SUSITNA HYDROELECTRIC PROJECT

VOLUME 10B

EXHIBIT E

APPENDICES I THROUGH J

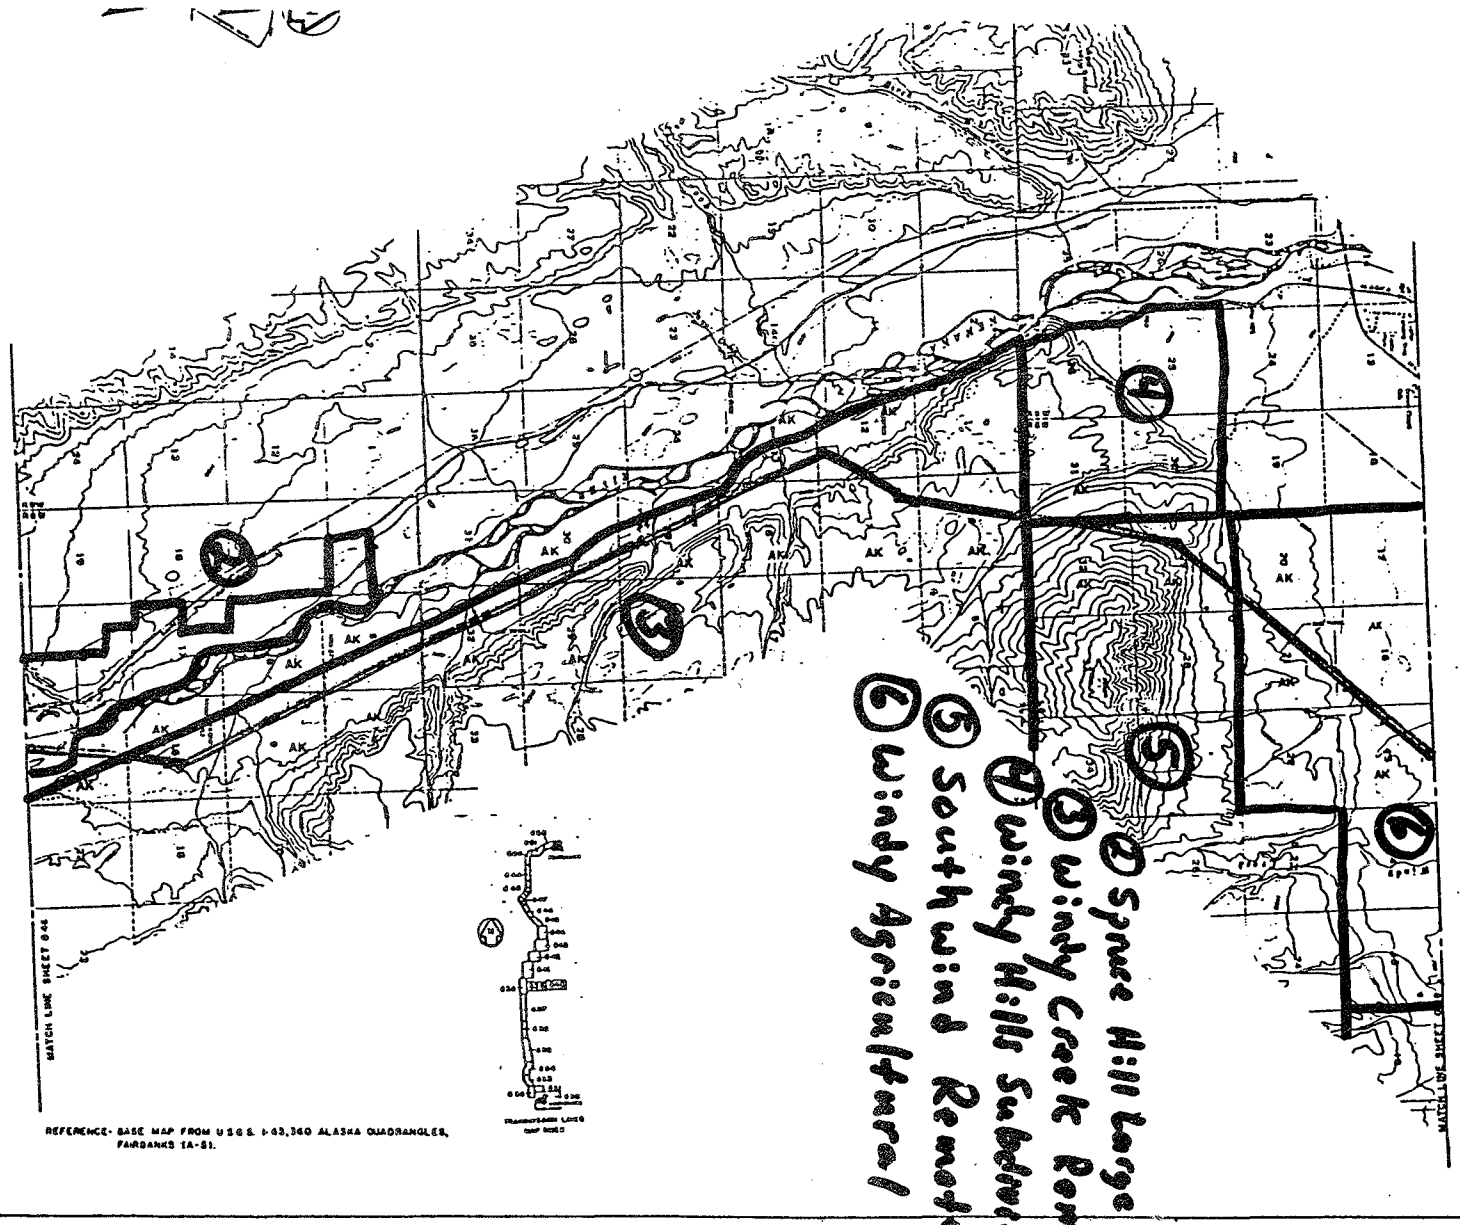
10. Northridge Subdivision: Portions of the proposed line appear to abut and/or cross into ASLS 81-214. All lots within this subdivision were sold in the last lottery and placement of the line in proximity to the subdivision would greatly effect the viewshed from the subdivision.

The overall District concern is the impacts the proposed right-of-way will have on land disposal actions and proper land management practices. Particularly, we would like to know why the new transmission line couldn't be placed adjacent to the existing transmission lines to lesson impacts? I am sure other questions and concerns will become evident as the project becomes more finalized. We look forward to working with you on the resolution of these conflicts. Please keep us informed on the progress of your studies in these matters.
